Product Change Notification: MFOL-21LXWA131

CCB 7210 Initial Notice: Qualification of MTAI as a new assembly site for SY89322VMG-TR, SY89251VMG-TR, SY89250VMG-TR, SY89206VMG-TR, SY89323LMG-TR, SY89222LMG-TR, SY89329VMG-TR, SY89328LMG-TR, and SY89321LMG-TR catalog part numbers (CPN) available in 8L VDFN (2x2x0.9mm) package.

PCN Type: Manufacturing Change

Pre and Post Summary – Leadframe Comparison

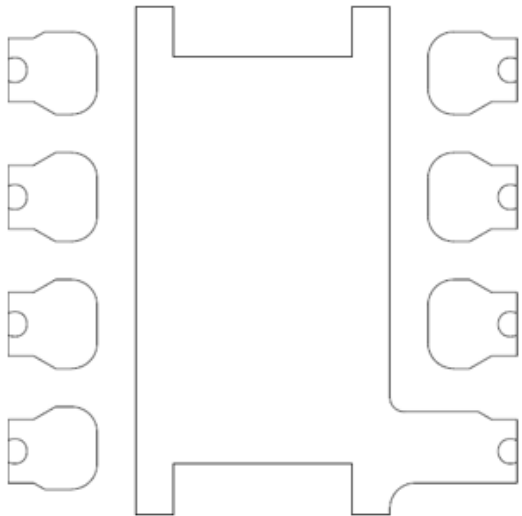
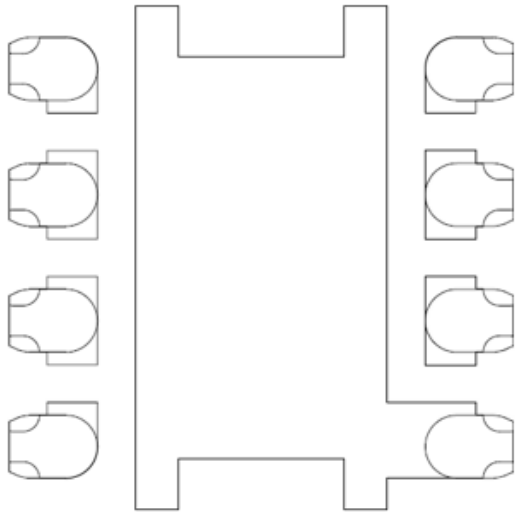
<table><tr><td>Leadframe Material</td><td>A194</td></tr><tr><td>Leadframe DAP Surface Prep</td><td>NiPdAu</td></tr></table>	Leadframe Material	A194	Leadframe DAP Surface Prep	NiPdAu	<table><tr><td>Leadframe Material</td><td>A194</td></tr><tr><td>Leadframe DAP Surface Prep</td><td>Bare Cu</td></tr></table>	Leadframe Material	A194	Leadframe DAP Surface Prep	Bare Cu
Leadframe Material	A194								
Leadframe DAP Surface Prep	NiPdAu								
Leadframe Material	A194								
Leadframe DAP Surface Prep	Bare Cu
